COMMENTS ON THE NUCLEAR WASTE MANAGEMENT ORGANIZATION'S INITIAL PROJECT DESCRIPTION

*Deep Geological Repository (DGR) for
Canada's Used Nuclear Fuel Project*

IAAC Ref# 88774

Submitted on behalf of Northwatch

Figure 1.2: General location of the Revell Site in northwestern Ontario. Inset map shows main figure location in Ontario.

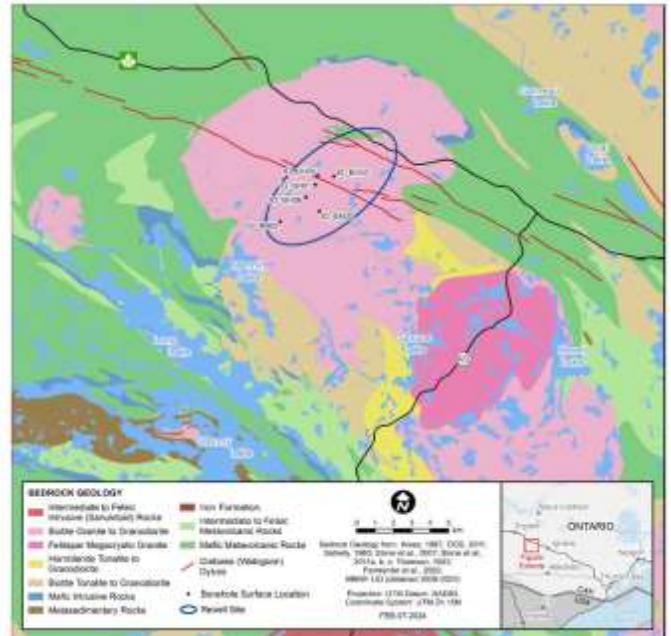
NWMO's 2023 report "Confidence in Safety – Revell Site"⁷⁶ referred to the site – as the report title would suggest – as the Revell site and that report included a map situating the site within the larger region⁷⁷ and a figure denoting the actual site boundaries (and within those site boundaries the drill holes).⁷⁸

and Township of Ignace area “ and failure to identify it by an actual site name is indicative of the larger issue. The failure to clearly map the Project site in a figure in the IPD is problematic.

While Figure 1.1 Project Location and Figure 1.2 Regional Communities in Section A.1 General Project Information situate the project very generally in maps that are 1:500,000 and 1:850,000 scale respectively, neither outline the site boundaries or the boundaries of the project study area. Similarly, while Figure 9.1 *Regional Communities* and Figure 9.2 *Currently Proposed Conceptual Site Plan* present a very generalized depiction of the “currently proposed conceptual site plan” neither identify the project site boundaries or the project study area.
